RE: Gilman Building Products: Perry Lumber  
AIRS ID Number: 120033, Project Number 005  
Response to Request for Additional Information, March 10, 2003  
D&A Project No.: 04100-288-02-4000

## RESPONSE TO THE DISTRICT REQUEST FOR ADDITIONAL INFORMATION

Taylor County – Air Permitting  
Gilman Building Products Company, LLC  
AIRS ID Number 1230033; Project Number 005  
Request For Additional Information Regarding TV Permit Renewal

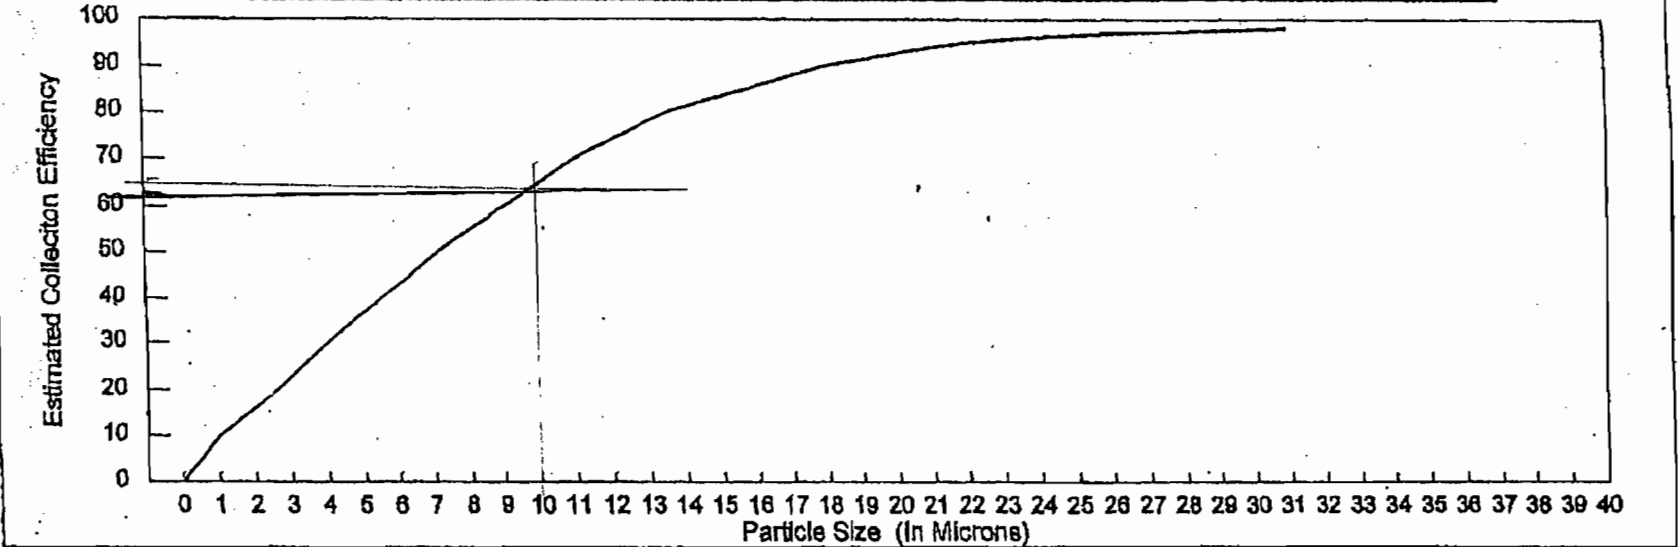
To respond to the CAM rule applicability, a hypothetical worst-case scenario was developed, where the pre-control device PM emission (X) was calculated using the greatest historical PM emission rate (8.08 lb/hr, 1998).

The pre-control device PM emission rate is 23.1 lbs/hr. The annual pre-control device emission is calculated below.

$$(23.1 \text{ lbs/hr}) * (8,760 \text{ hrs/yr}) * (1/2000 \text{ tons/lb}) = 101.1 \text{ tons/yr}$$
